# FOREST HEIGHTS ESTATES GRADING & EROSION CONTROL PLANS

FOR FOREST HEIGHTS CIRCLE  
COUNTY OF EL PASO, STATE OF COLORADO

**COUNTY ENGINEERING:** EL PASO COUNTY PLANNING & COMMUNITY DEV  
2880 INTERNATIONAL CIRCLE, SUITE 110  
COLORADO SPRINGS, CO 80910

**FOREST HEIGHTS CIRCLE  
GRADING & EROSION CONTROL PLAN**  
TITLE SHEET

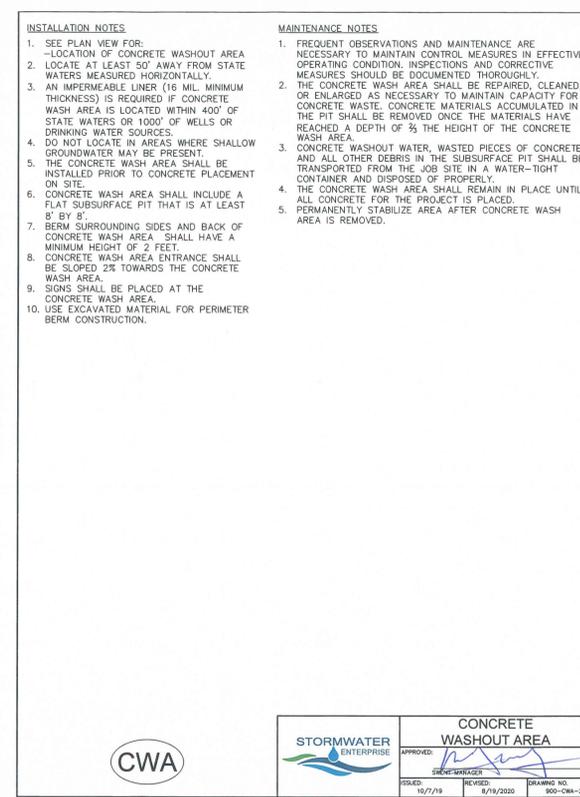
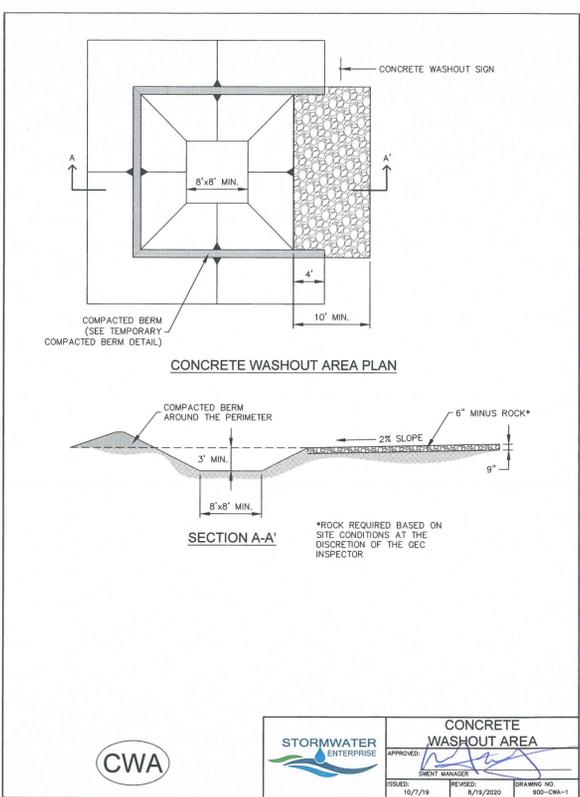
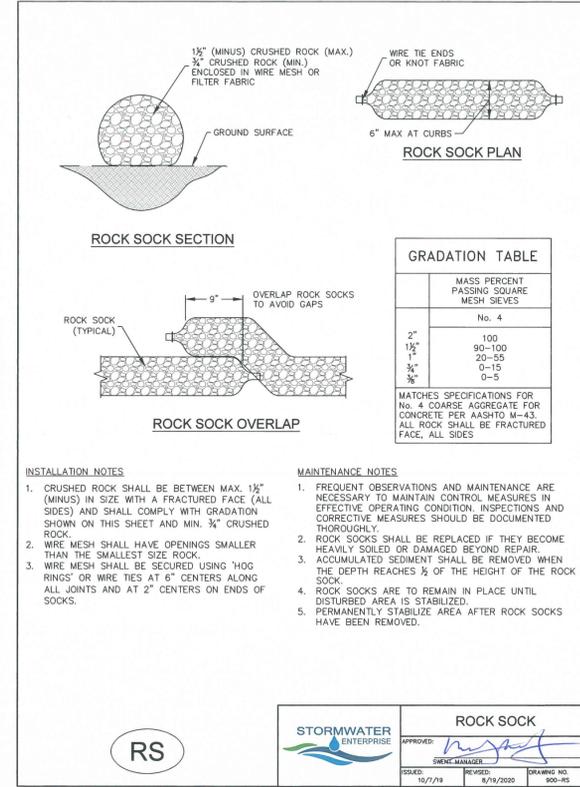
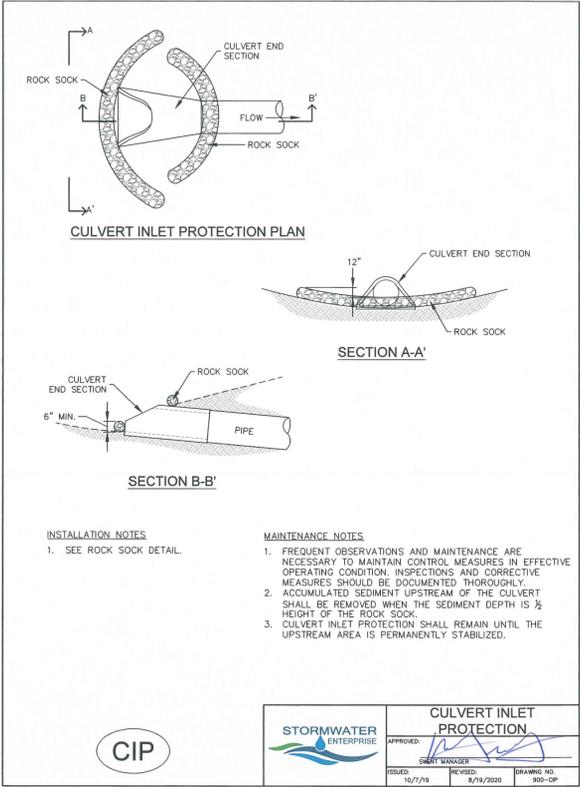
Comment generated due to changes in the document from previous submittal, per my comment on pdf pg 93 of the v3 FDR:  
It is unclear how these grass species compare to those in DCMv1 Chap 10.7, Table 10-4. Please clarify with a note here or via a discussion in the FDR what velocity and slope is permissible with these species since these are not shown on Table 10-4.

**FOREST HEIGHTS CIRCLE GRADING & EROSION CONTROL PLAN**  
GENERAL NOTES AND EROSION CONTROL DETAILS

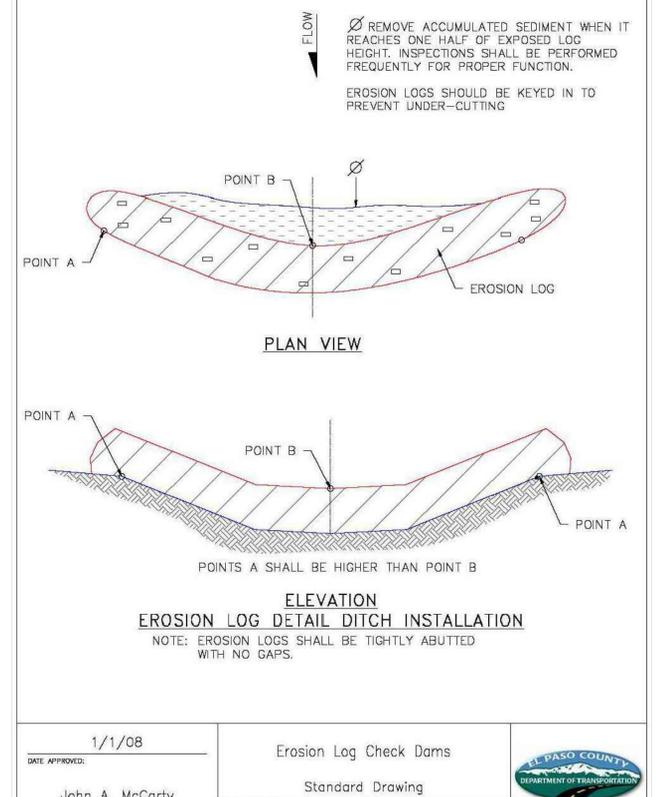
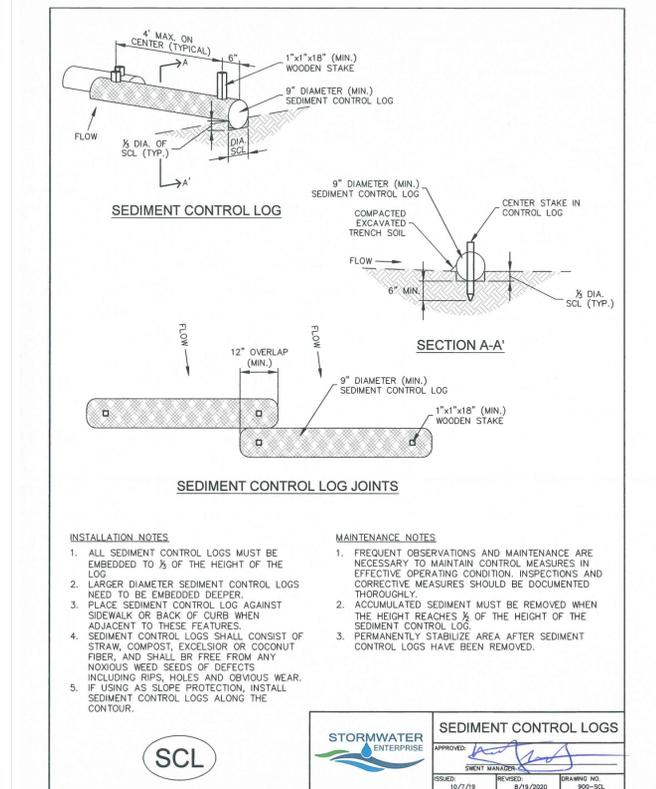
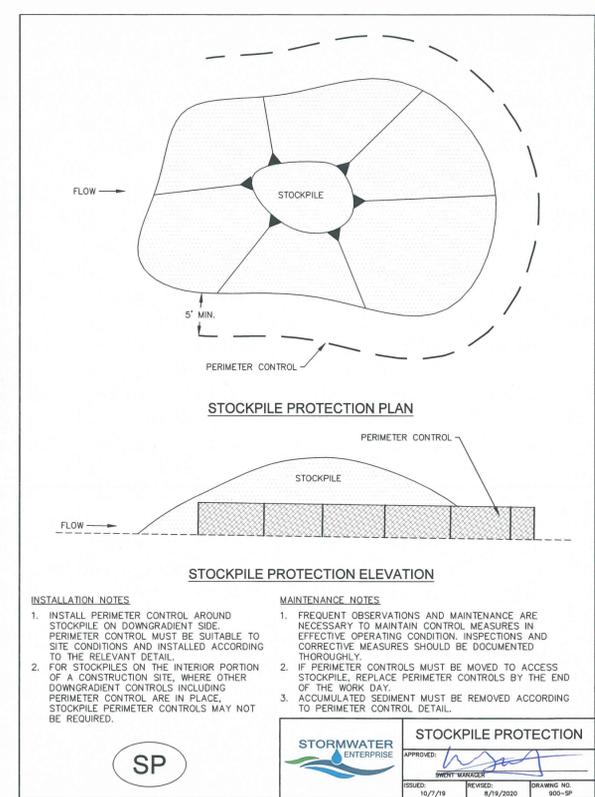
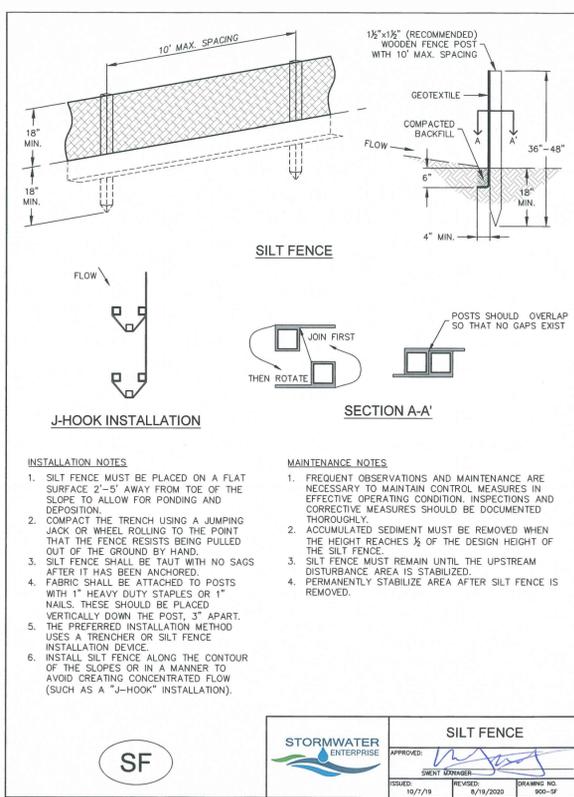
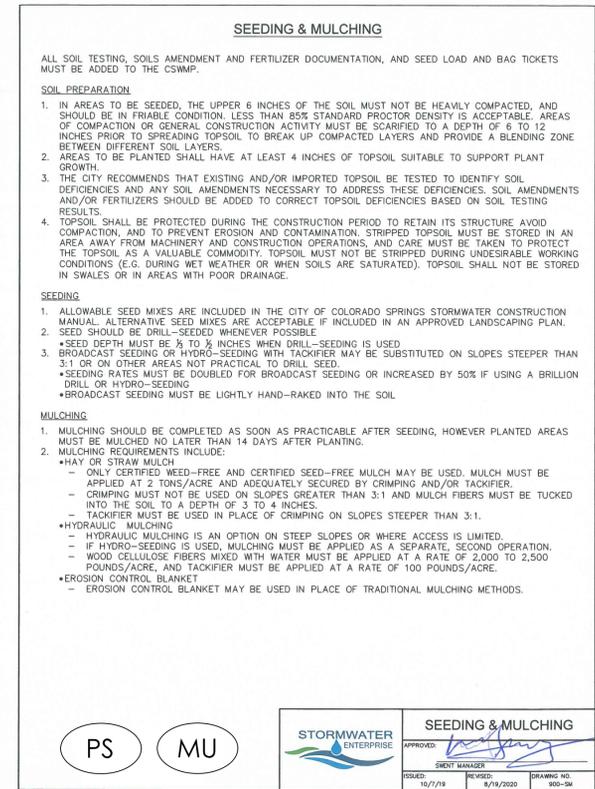
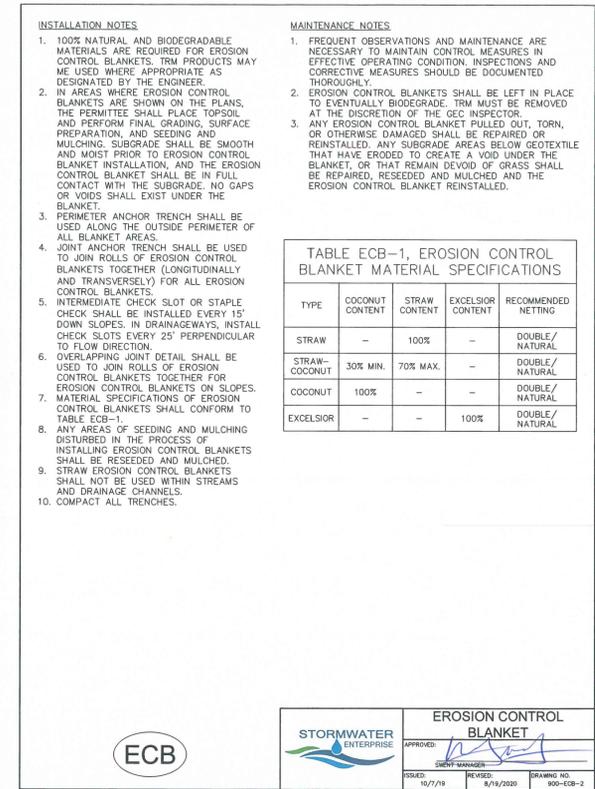
With Review #2 and #3, I asked for the VTC detail to be revised/replaced to meet our EPC criteria. With this Submittal #4, the detail was removed completely. A detail is needed since a VTC is still shown on the GEC Plan below. So please add in an acceptable VTC detail with a min 75ft length. For reference, below is my Review #3 comment:

Unresolved previous comment from Review #2:

If a VTC is added to the plans above, add a VTC detail to this sheet. And make sure to use a EPC approved VTC detail (VT-1 and VT-2 in DCMv2, Chap 3.3) or revise other detail (which usually have 50ft length) to be 75ft min length.

EROSION CONTROL

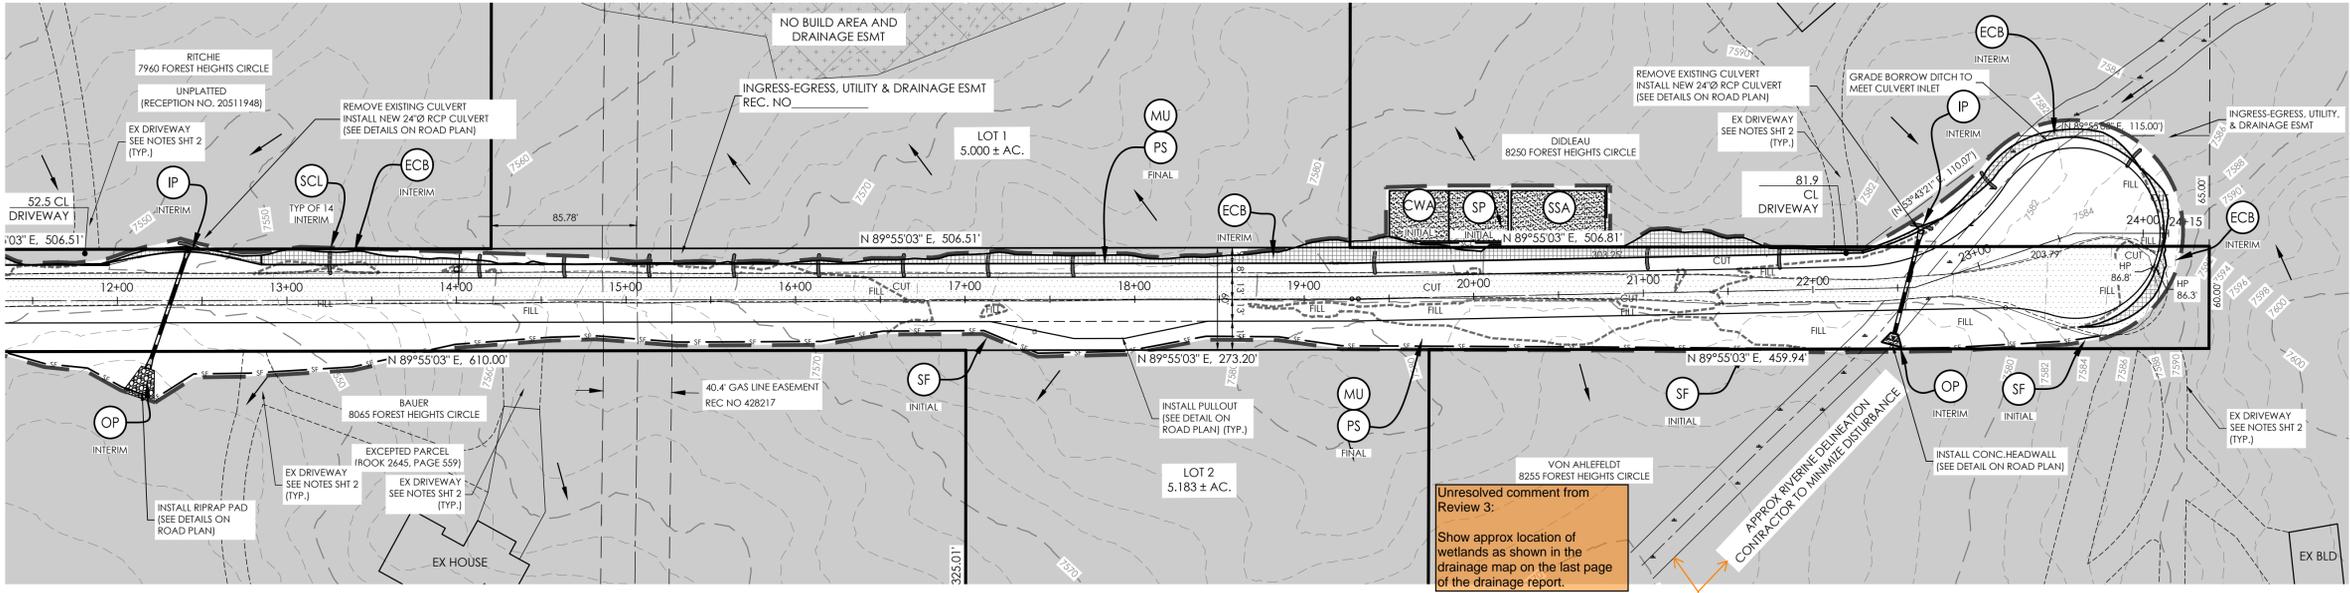
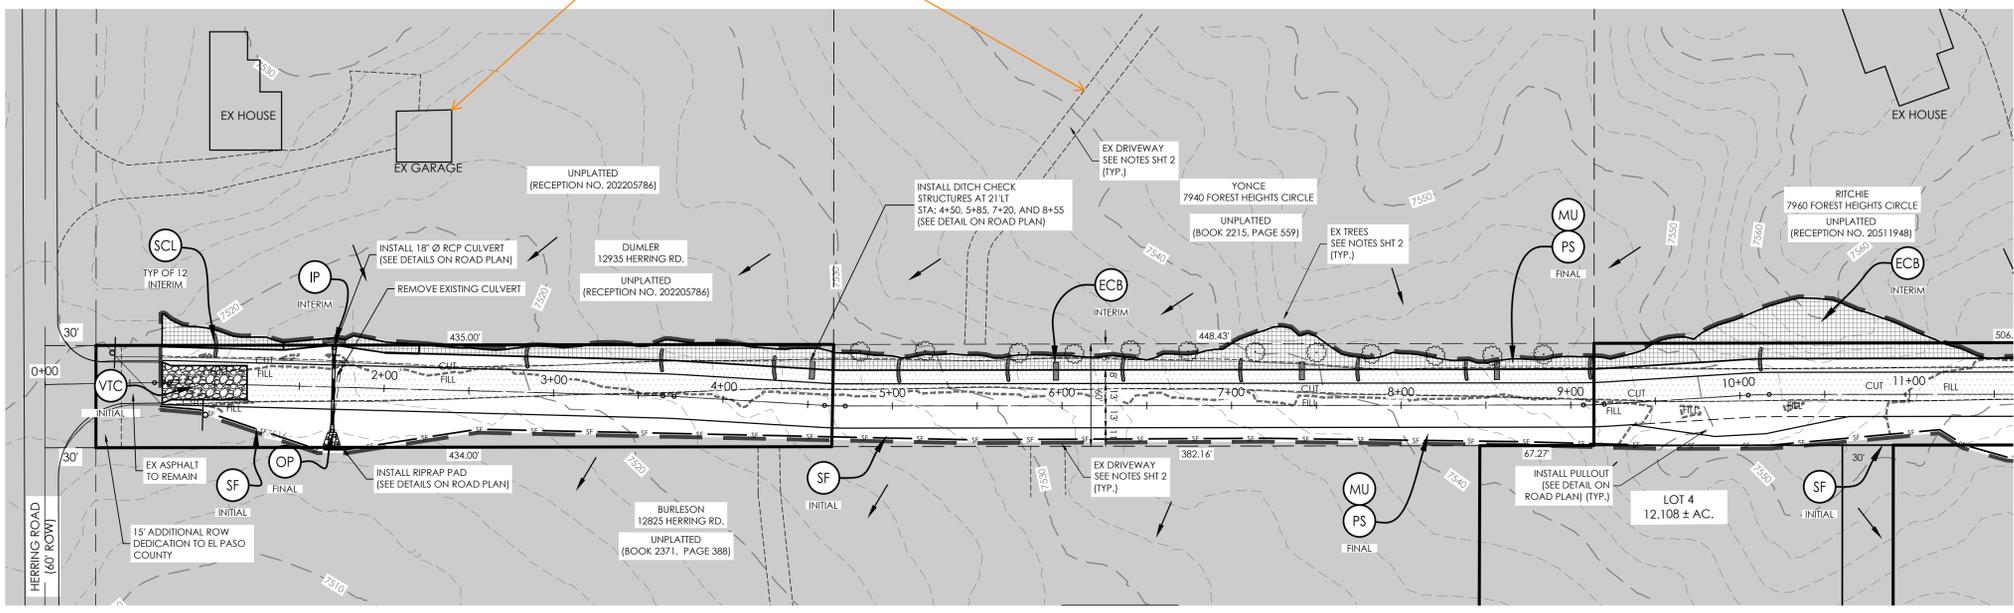
Show these approx locations of building footprints and driveways on FDR drainage map.

With this submittal, all proposed topo was "turned off" so is not visible. Please include all proposed topo on these plans with the next submittal.

Unresolved comment from Review 3:  
Show location of driveway culverts.

Unresolved comment from Review 3:  
Show approx location of wetlands as shown in the drainage map on the last page of the drainage report.

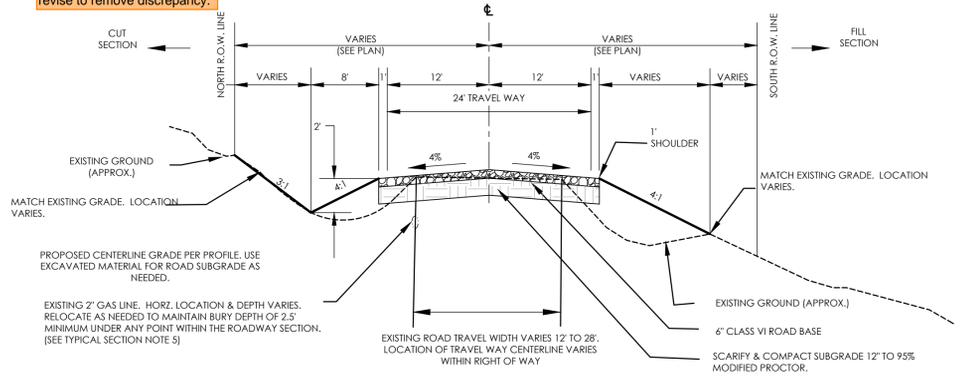
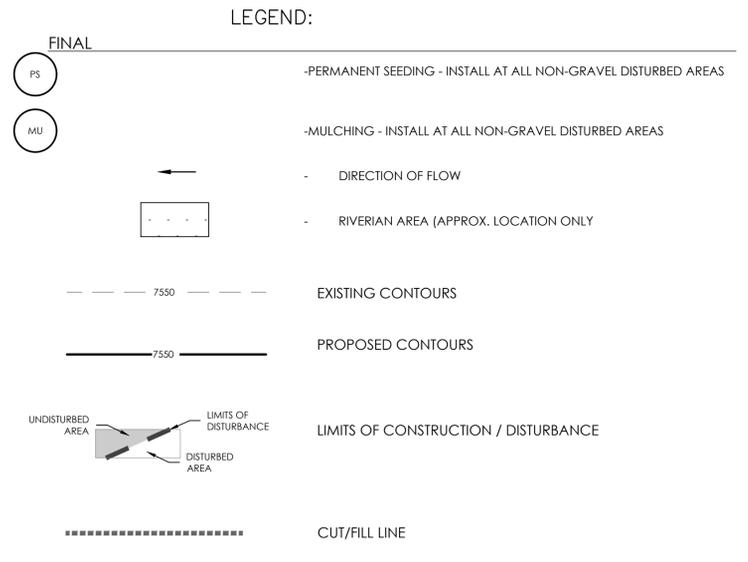
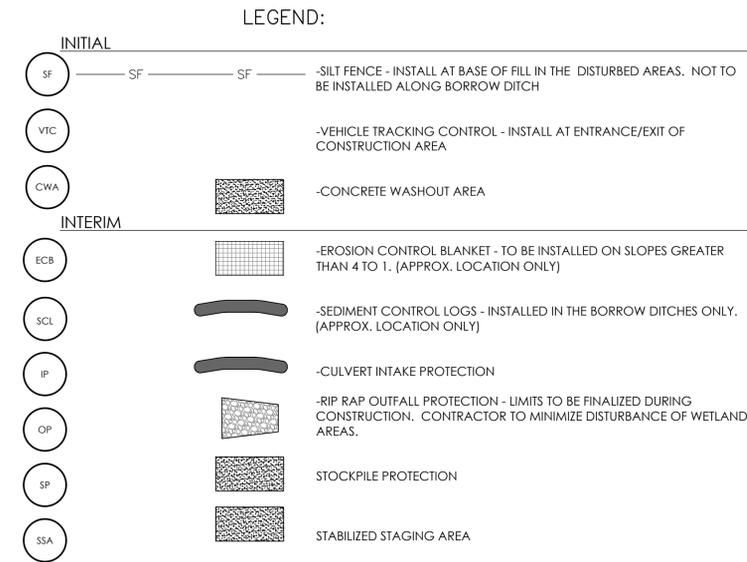
This area was not shown with the last submittal and is not shown in the FDR. Please revise to remove discrepancy.
